Design Advisory Board

Tuesday, August 26, 2025, 3:00 PM

To: Design Advisory Board
From: Scott Gustin
Re: 147 South Cove Road
Date: August 26, 2025

File: ZP-25-313
Location: 147 South Cove Road
Zone: RL **Ward:** 5S
Parking District: Neighborhood
Date application accepted: June 27, 2025, Complete July 21, 2025
Applicant/ Owner: Paul Rosenfeld
Request: Construct new single family home on existing vacant lot.

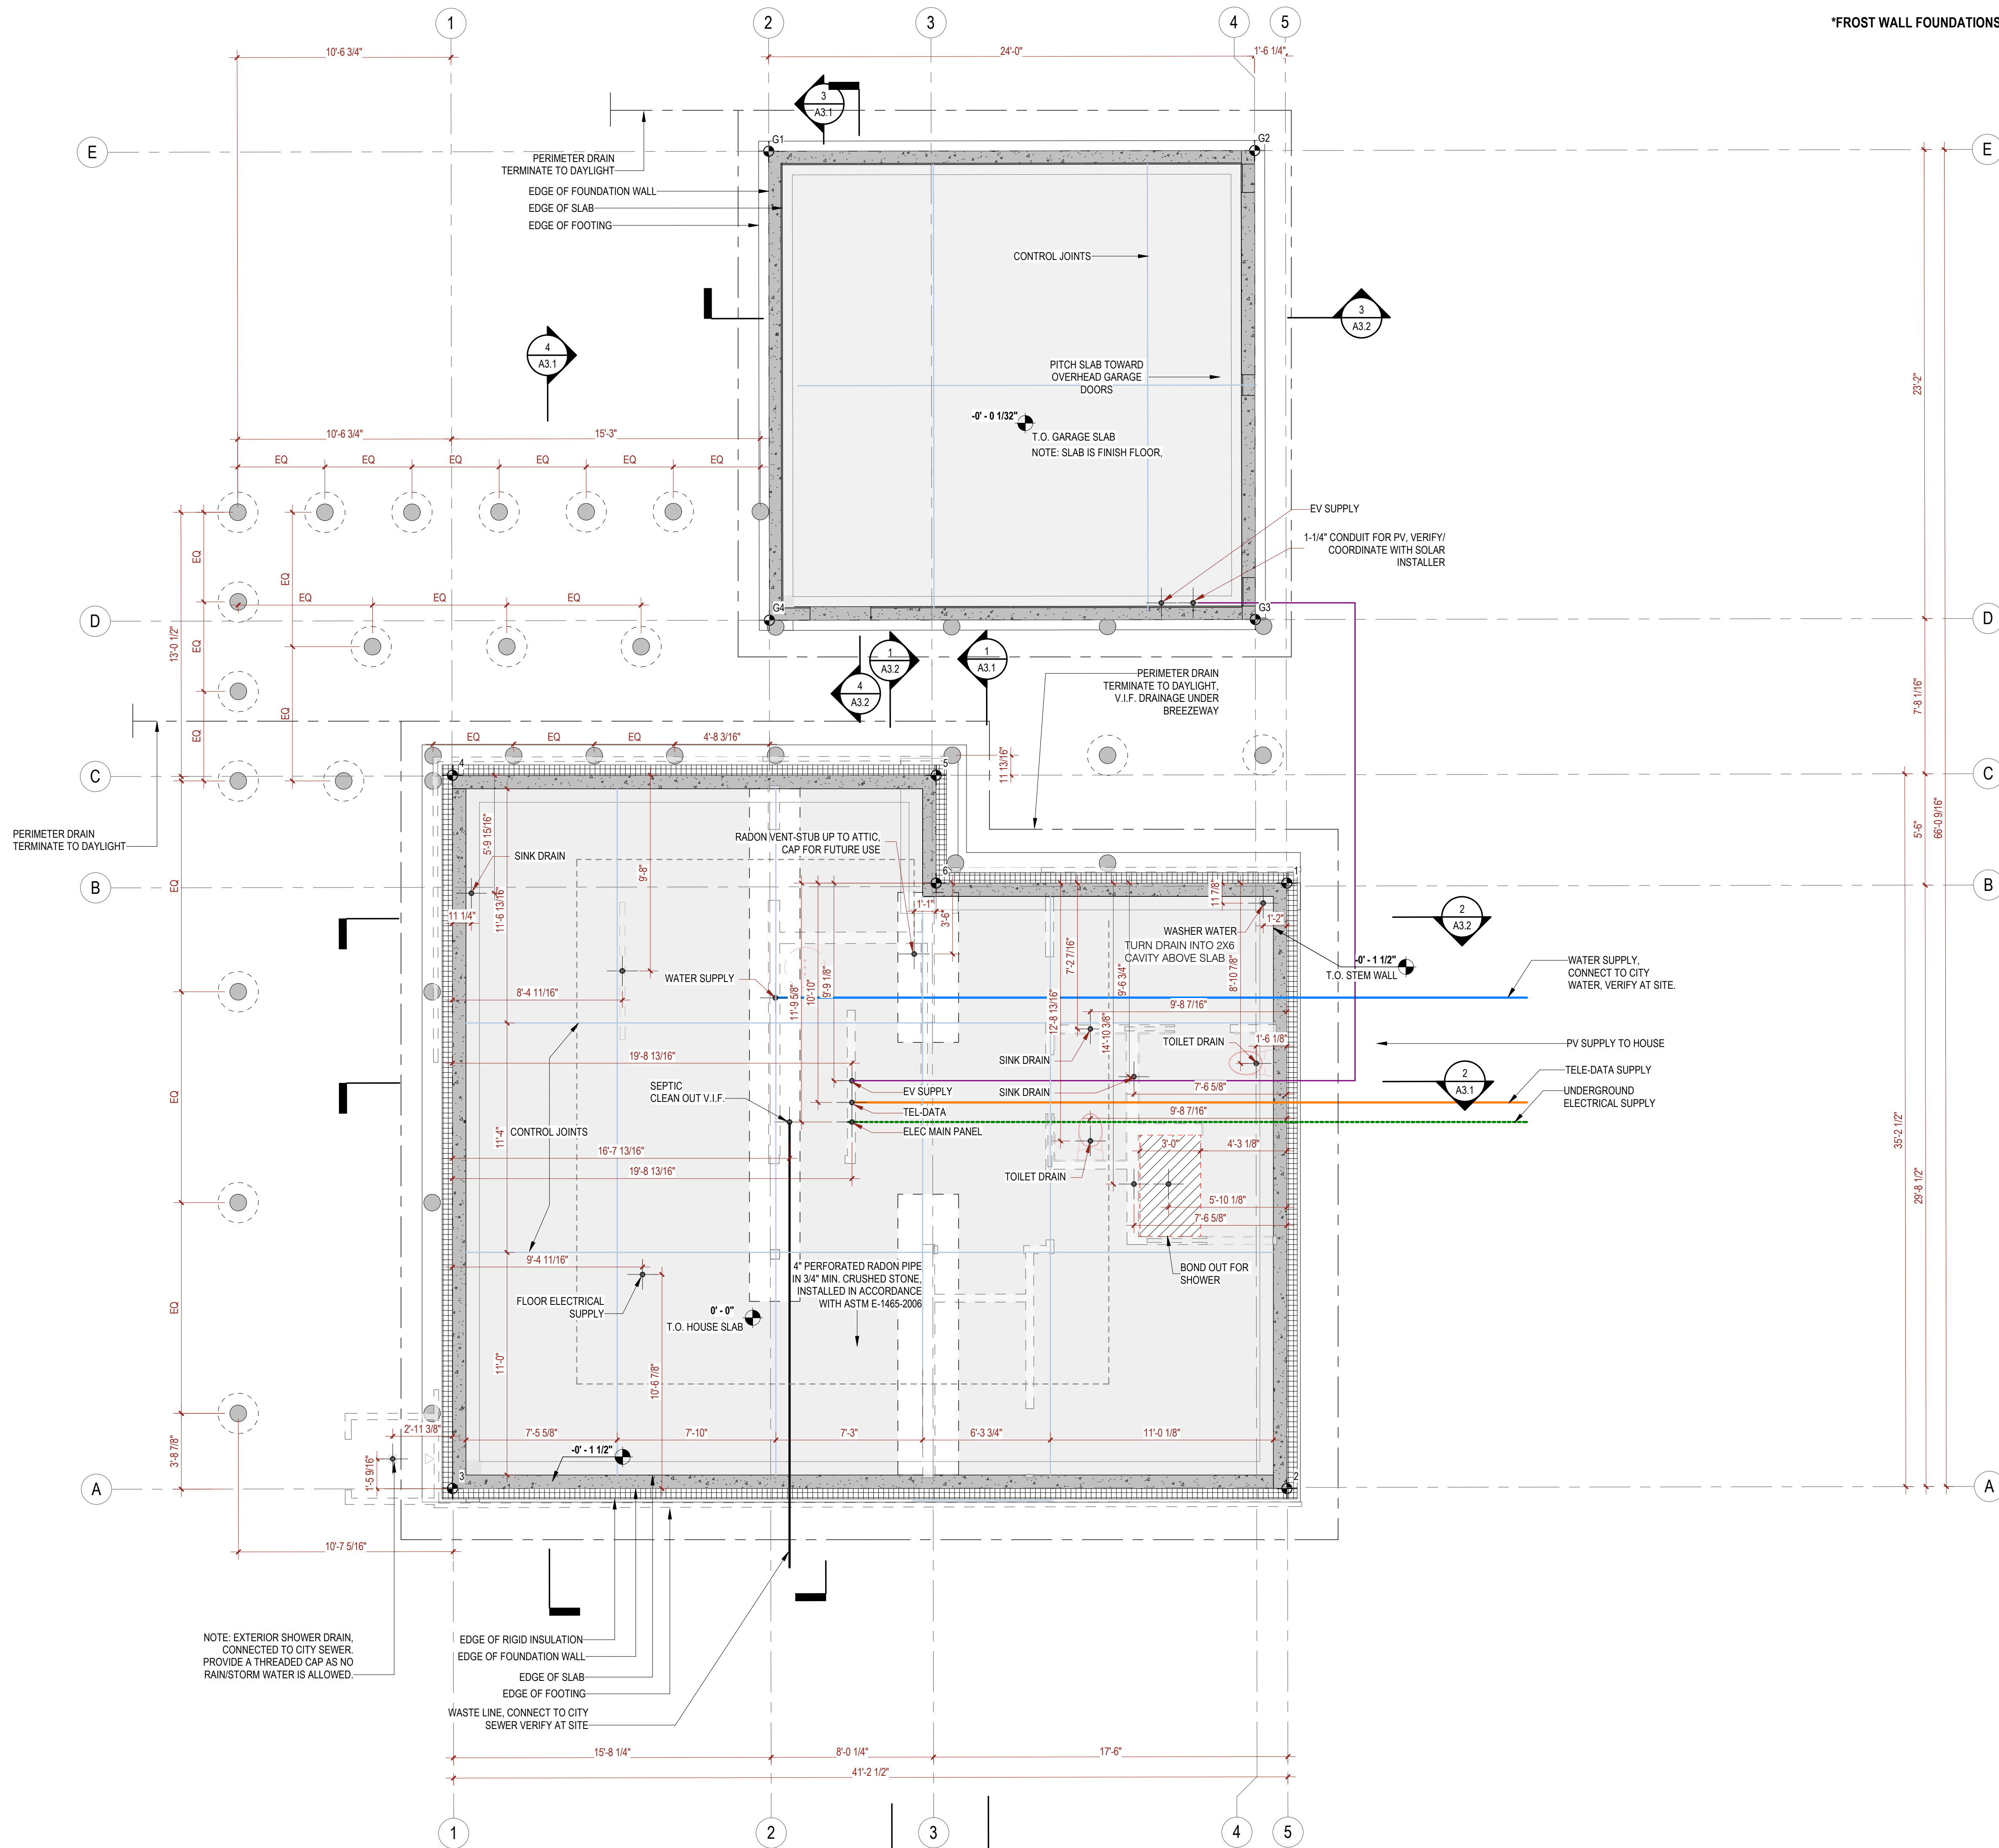
This criterion requires that a pedestrian walkway be provided from the front door to the public sidewalk or street. There is no sidewalk on this side of South Cove Road; however, the road is public. A front walkway is not present in the site plans and must be included. Convenient access between the driveway and front entry is proposed.

Residential driveways are limited to 18' in width. As proposed, the driveway generally complies with this limitation; however, a turn-around in front of the breezeway connecting the house to the garage results in a driveway width exceeding 18.' In several similar previous cases, the turn-around has been constructed of a different material than the driveway and has served a dual use such as part of the entry into the home or a basketball half court. Alternatively, the turn-around could be deleted. In either case, site plan revision is needed.

The site plans depict existing vegetation to be retained and the required low-mow zone along the waterfront. No landscaping plan is evident and is required. At least species, placement, and size at the time of planting should be included. No fencing or retaining walls are proposed.

1. Stormwater management plans are needed, subject to Water Resources review and approval.
2. Revised project plans addressing the following are needed:
 - a. A front walkway connecting to the public street;
 - b. Adjustment of the driveway and turn-around that differentiates the turn-around with a material different than that of the driveway;
 - c. A landscaping plan is needed and must include species, locations, and size at the time of planting;
 - d. Lumen information for the exterior sconce fixtures; and,
 - e. Street-side screening of the heat pumps.

Existing site, Google Earth view.

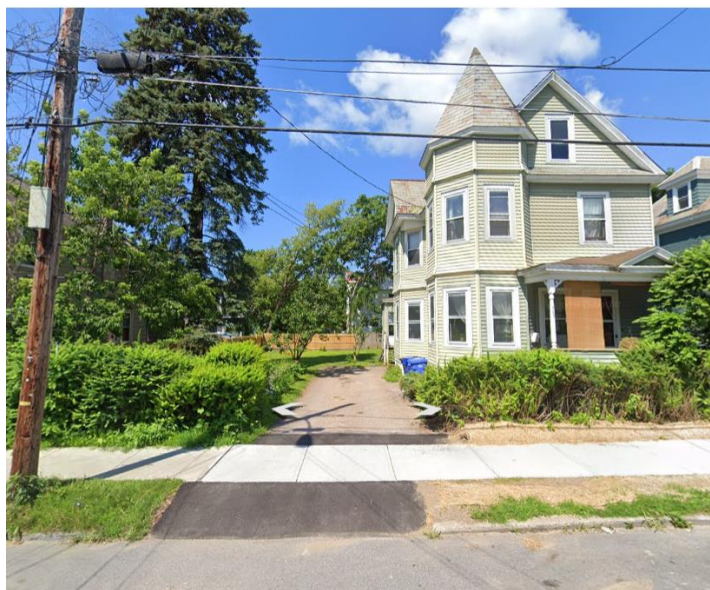
Other than the removal of a conifer tree, no landscaping plan has been provided and no tree removal plan submitted. Plan A1.1 lacks site details.

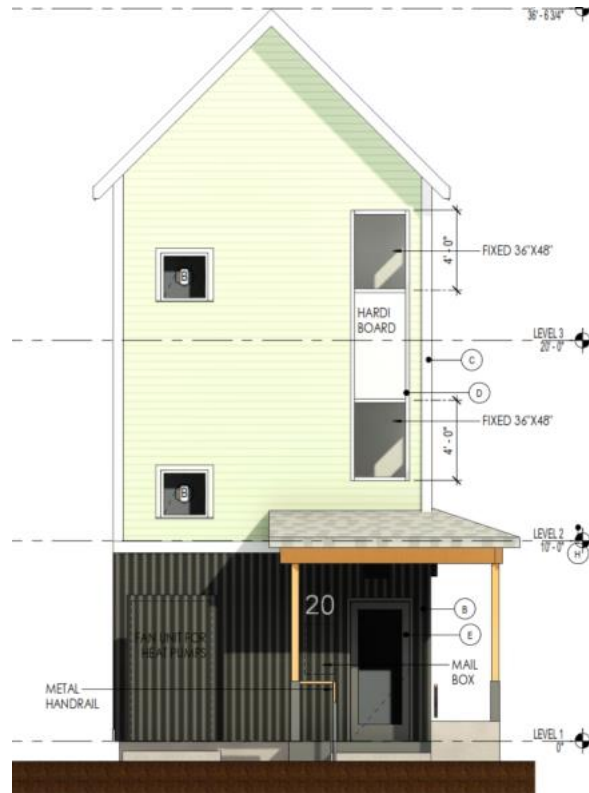
The proposed Secondary Structure is recessed from the structural street wall of Isham St; placed almost 40' from the front property line (while the existing primary structure is less than 10'). It deviates from the alignment of the remainder of the buildings along Isham (*"should be aligned with the front façade of neighboring buildings to reinforce the street edge..."*) This arrangement is due to footnote 5, Table 4.4.5-2:

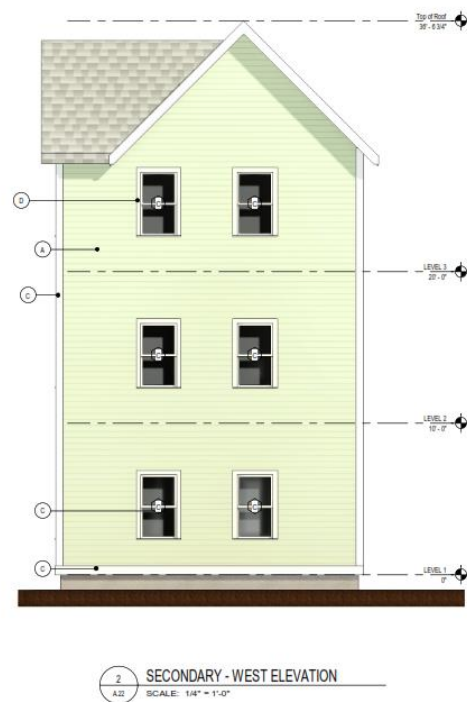
The building design is successful in appearing more vertical than horizontal. The only gesture towards interest and complexity is the minor cross-gable. The plan's interpretation of variation in materials is wrapping the entrance in corrugated metal while sheathing the rest of the arrangement in vinyl.
